Serial No. NA3-12-011R
Docket No. 52-017
COL/DBE

DOMINION VIRGINIA POWER
NORTH ANNA UNIT 3 COMBINED LICENSE APPLICATION
SRP 09.02.05: RESPONSE TO RAI LETTER 99

SRP SECTION: 09.02.05 – ULTIMATE HEAT SINK

Figure 9.2.5-1R
(Sheet 1 of 2)

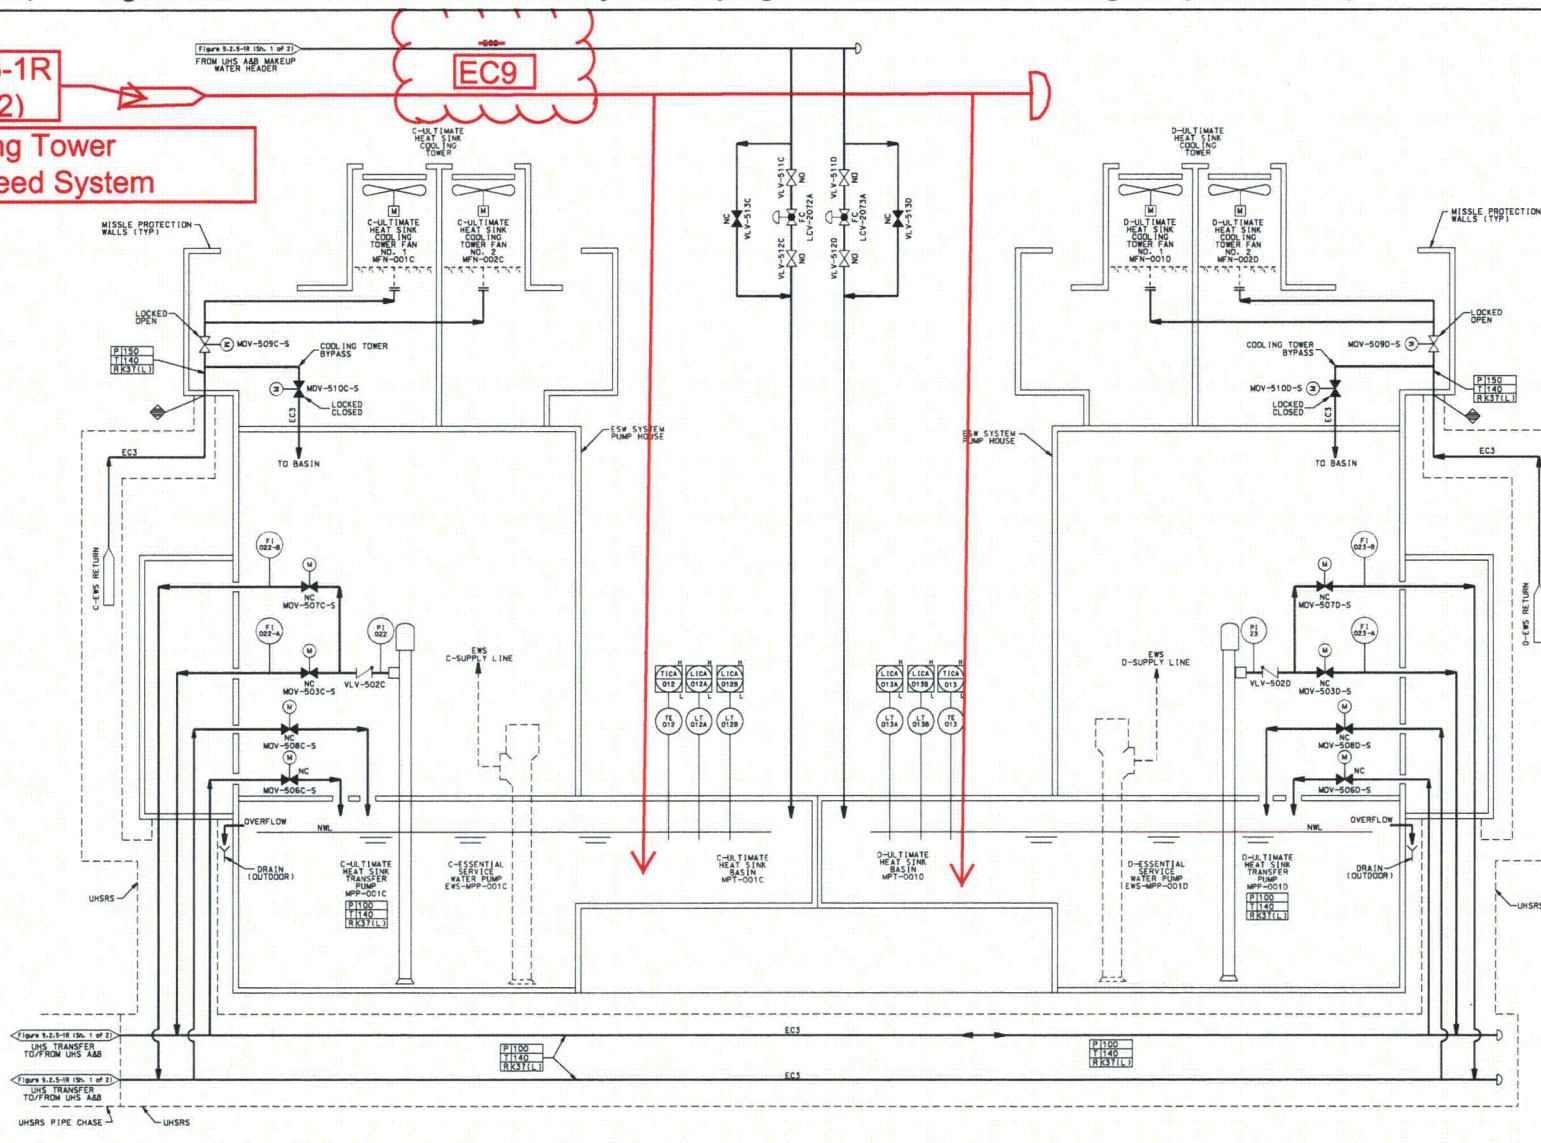
UHS piping materials (including the UHS transfer piping material) which is not adequately described in the FSAR. For the UHS piping system, outside the scope of the Essential Service Water System (ESWS), describe the materials to be utilized (carbon or alloy), ASME Code class, and if the system is internal lined and/or has cathodic protection. This FSAR description should be similar to the description in US-APWR DCD and COL FSAR Sections 9.2.1.2.2.5, "Piping" (ESWS).

Dominion endorses Luminant's response to Comanche Peak RAI 6358, Question 09.02.05-19, submitted June 7, 2012 (ML12163A012), which describes that the UHS piping material, including the UHS transfer piping, is carbon steel with an internal polyethylene lining. The piping is not buried, so cathodic protection is not provided. The following clarification is made to Luminant's response:

The "CW makeup water main header line" in the Comanche Peak R-COLA is referred to as the "Cooling Tower Makeup and Blowdown System Line" in the North Anna Unit 3 COLA and has an equipment classification of EC9.

FSAR Subsection 9.2.5.2.1 and Figure 9.2.5-1R will be revised as indicated on the attached markup.

Figure 9.2.5-1R(Sheet 2 of 2)

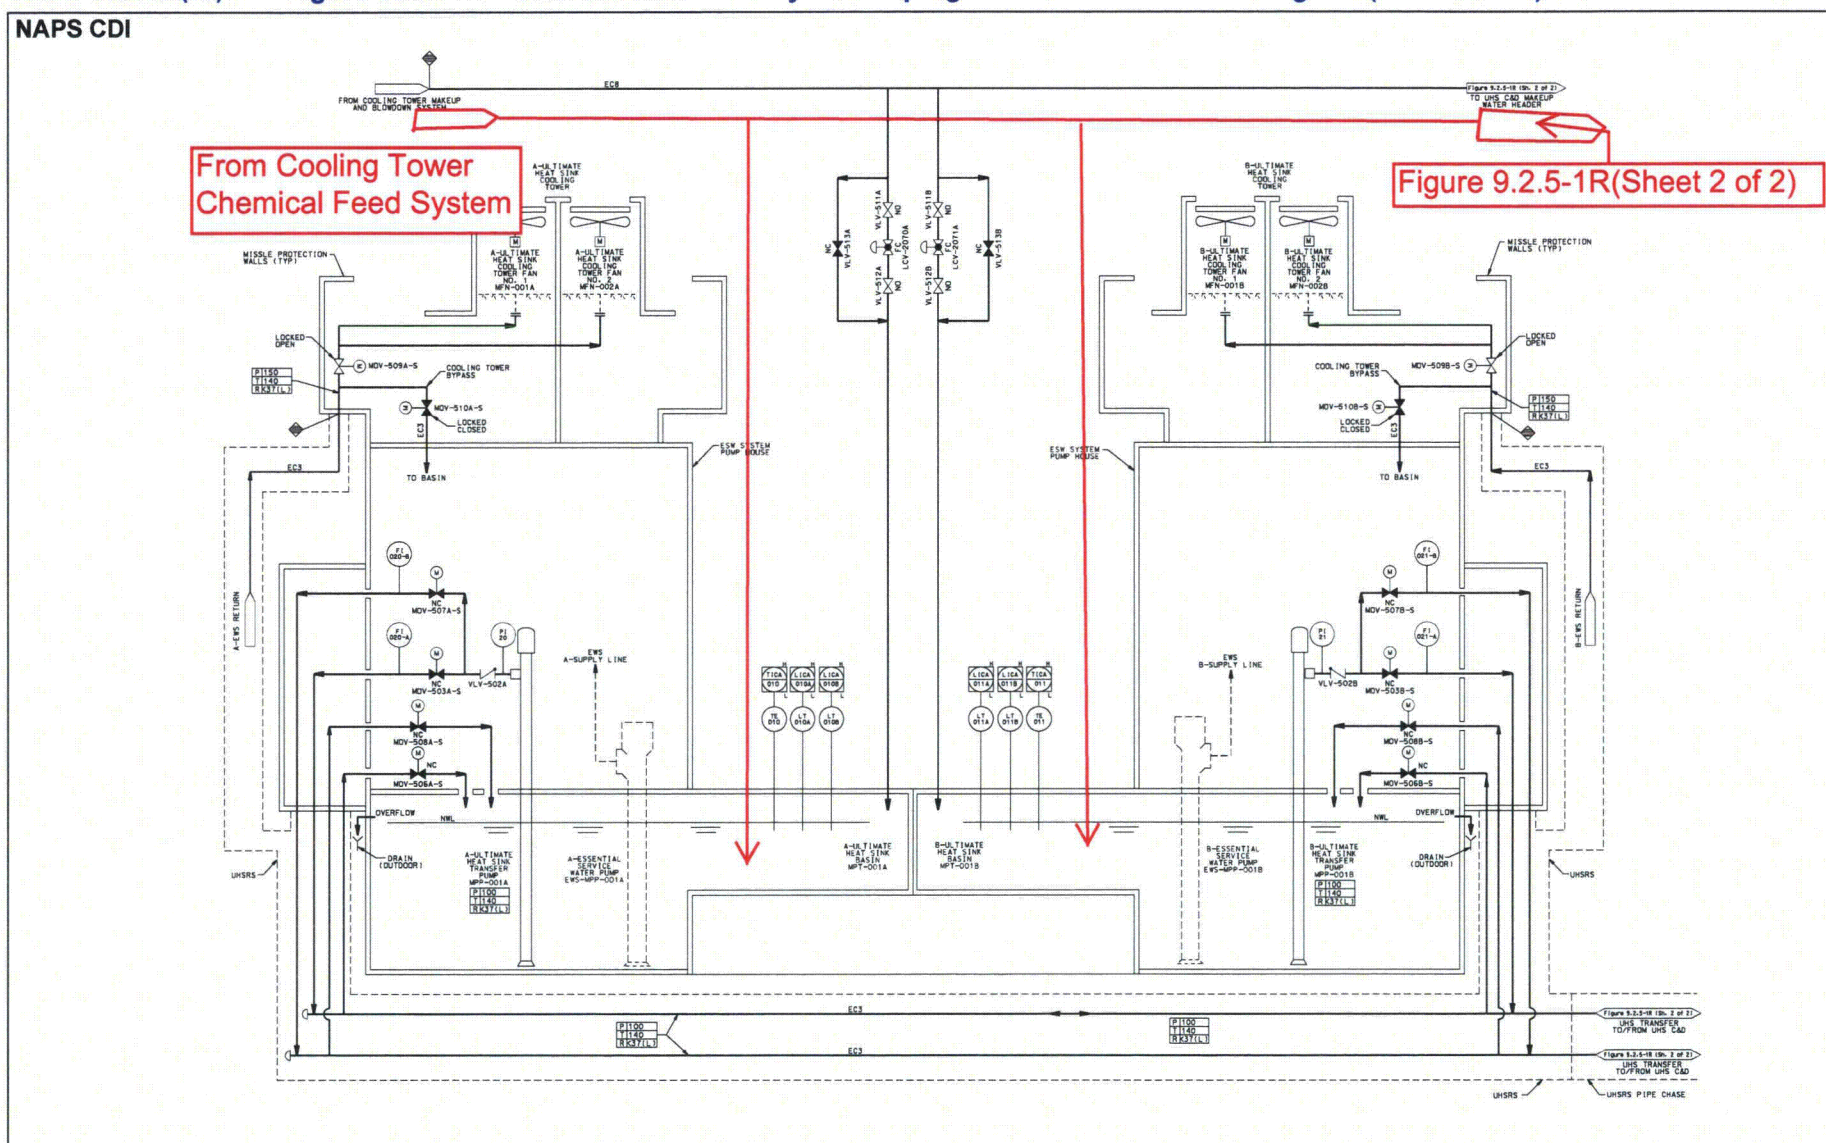
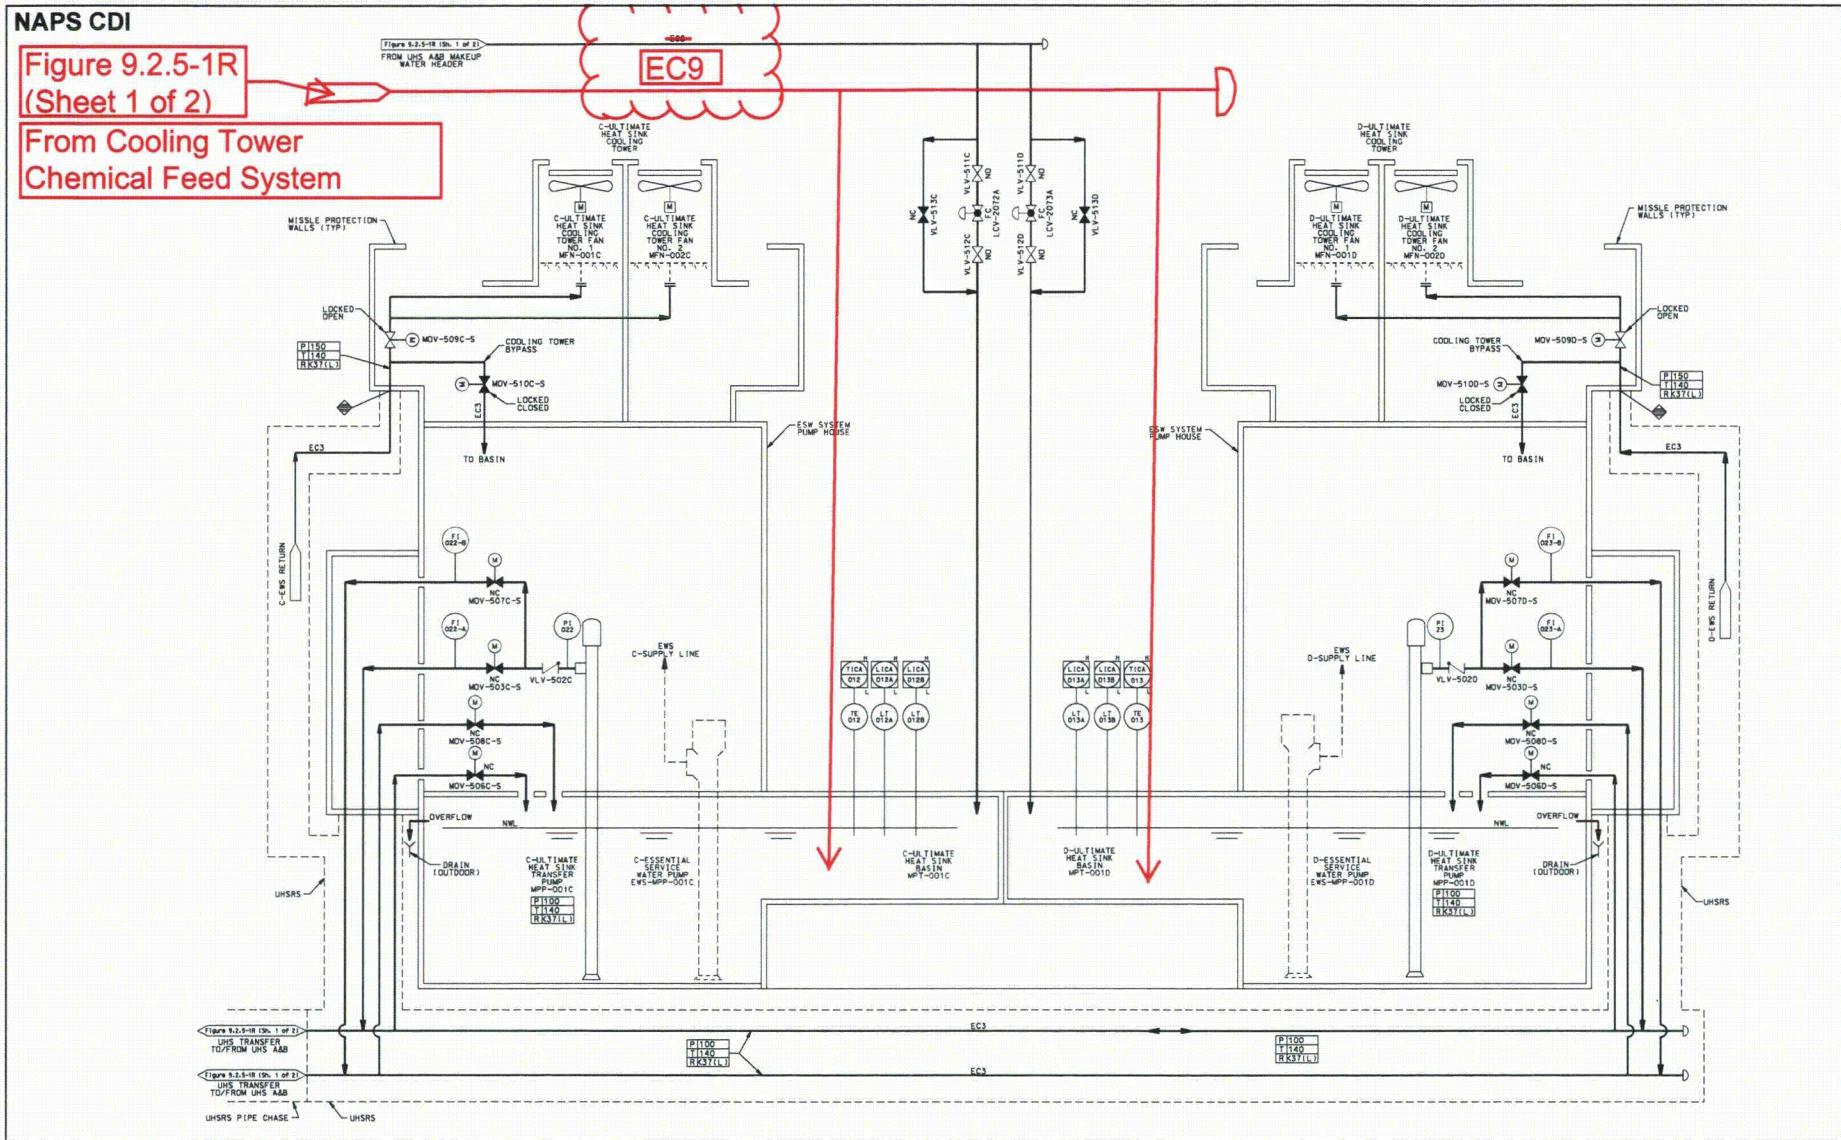
- (1) Given a possible seismic event, describe if a UHS basin siphon event is possible (drain-down event) from the interconnection with the nonsafety-related normal water basin makeup from the circulating water system (CWS) (Figure 9.2.5-1R).
 - (2) Describe how normal make-up from the CWS is isolated during accident conditions to preclude flooding the UHS basins.
 - (3) Clarify location of the makeup control valves shown on Figure 9.2.5-1R, since they appear to be between the two cooling towers.
 - (4) Chemical treatment (used to limit biological film formation) of the UHS basin during normal operations and accident conditions is not clearly described in Sections 9.2.5 or 10.4.5.2.2.8 of the FSAR. Section 9.2.1 of the FSAR points to Section 10.4.5.2.2.8 which has insufficient information relating to the UHS basin and chemical injection.
-

- (1) Dominion endorses Luminant's response to Comanche Peak RAI 6358, Question 09.02.05-23, submitted June 7, 2012 (ML12163A012), which describes that a UHS basin siphon event has minimal impact on the amount of water available to the UHS/ESWS.
- (2) Since the normal make-up water line from CWS is non-safety related, it may not be isolated during accident conditions. The failure of the normal make-up water line to isolate does not have an adverse safety impact for the following reason:

FSAR Subsections 9.2.1.2.1, 9.2.5.2.1, 9.2.5.2.2, 9.2.10, 10.4.5.2.2.8 and FSAR Figures 9.2.5-1R sheets 1 and 2 and Figure 10.4.5-203 will be revised, as indicated on the attached markup.
